**STATE OF TENNESSEE  
DEPARTMENT OF TRANSPORTATION**

**INSTRUCTIONAL BULLETIN NO. 22-03**

**Regarding Various Revised and New Standard Drawings**

**Effective August 19, 2022 letting (June 8, 2022 Turn-in)**, the following Standard Drawings have been revised or are new. In addition, Chapter 10 of the Roadway Design Guidelines - Index of Standard Drawings and the web site have been updated accordingly and are available online.

SECTION C-C

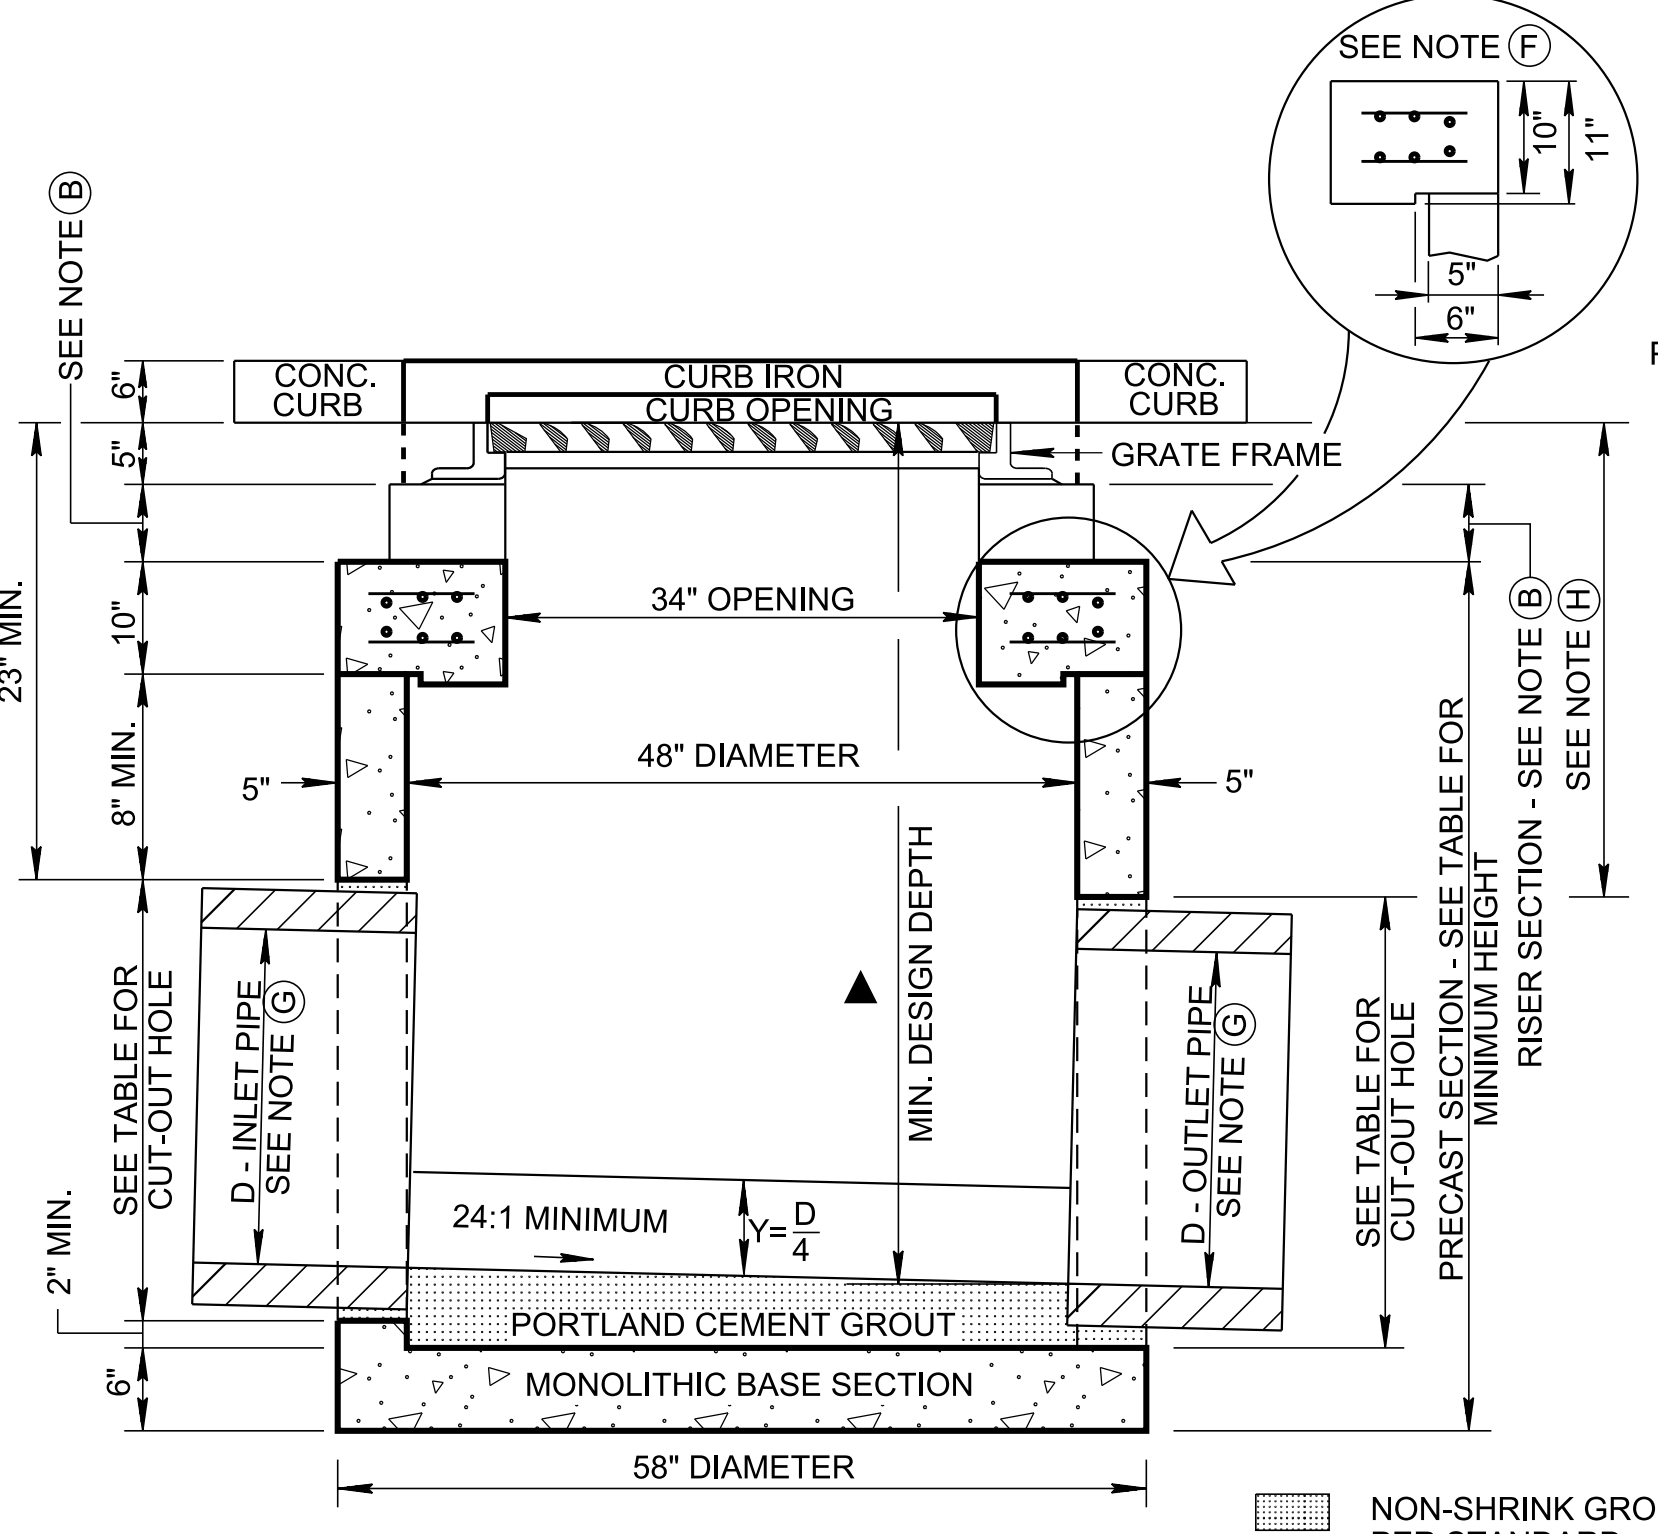
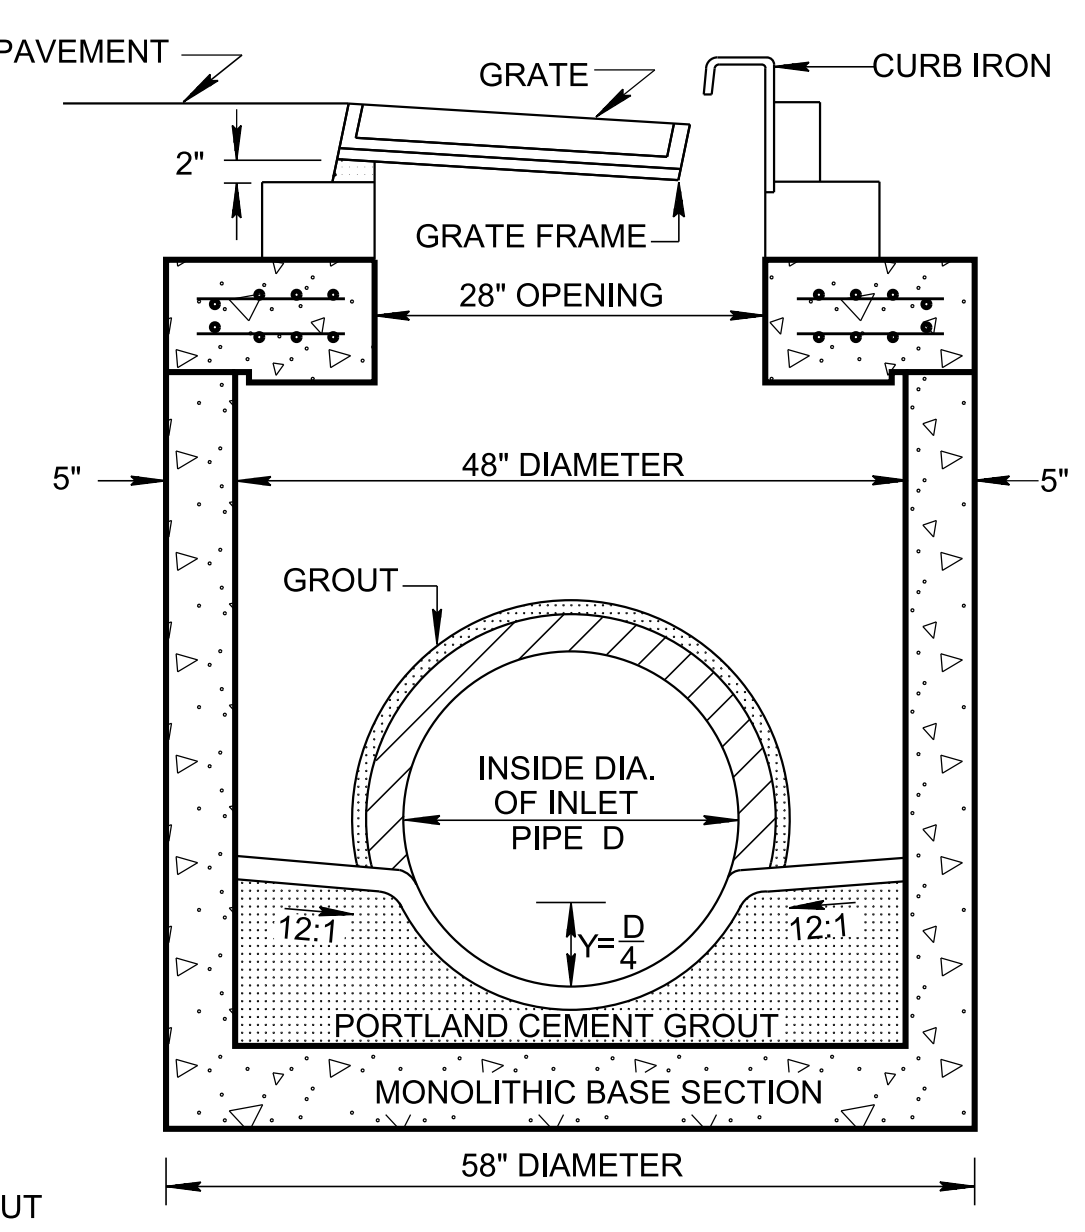
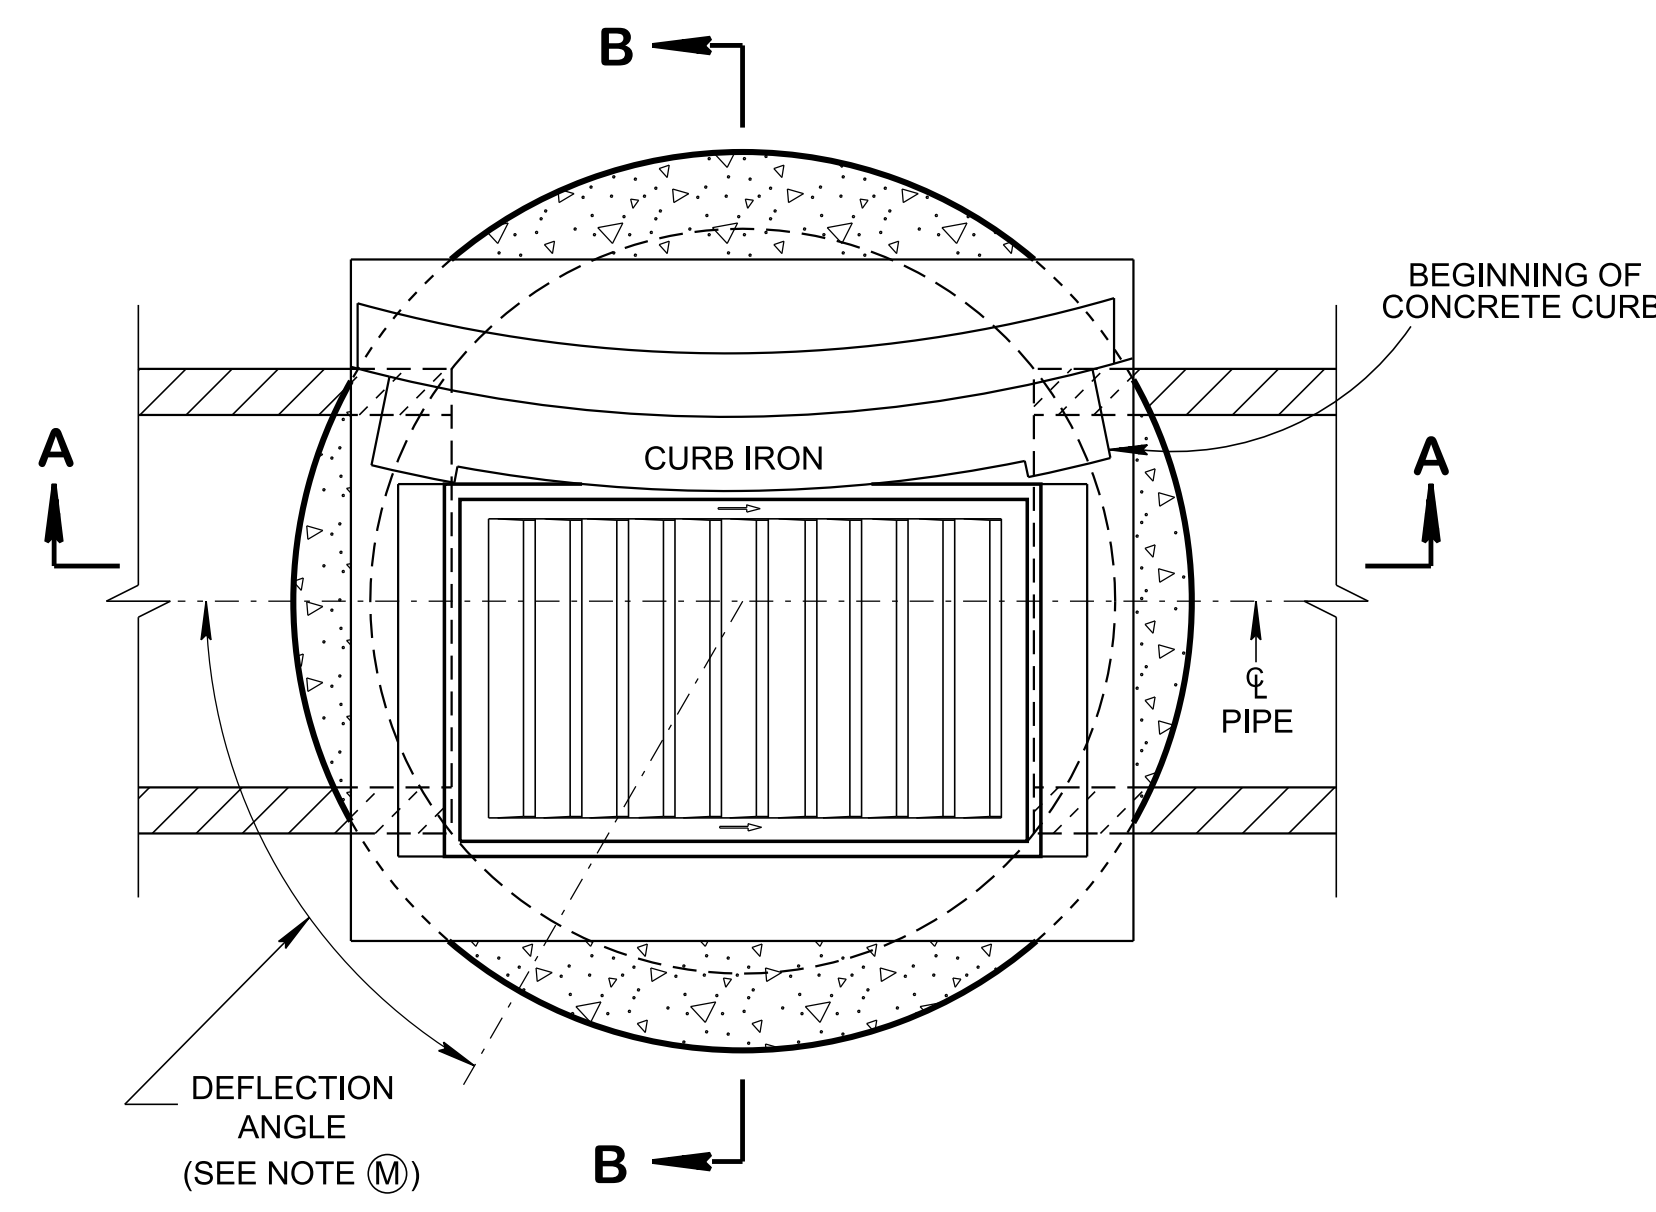
- REV. 02-20-2020: REDREW SHEET.
- REV. 01-28-2022: DEFLECTION ANGLE NOTE ON PLAN VIEW, AND GENERAL NOTES (L) AND (M) WERE ADDED.

- (L) SEE STANDARD DRAWING D-CB-99RA FOR BILL OF STEEL FOR CATCH BASIN LIDS.
- (M) CONNECTION OF 24" PIPES WILL BE LIMITED TO 60 DEGREE DEFLECTION ANGLE.
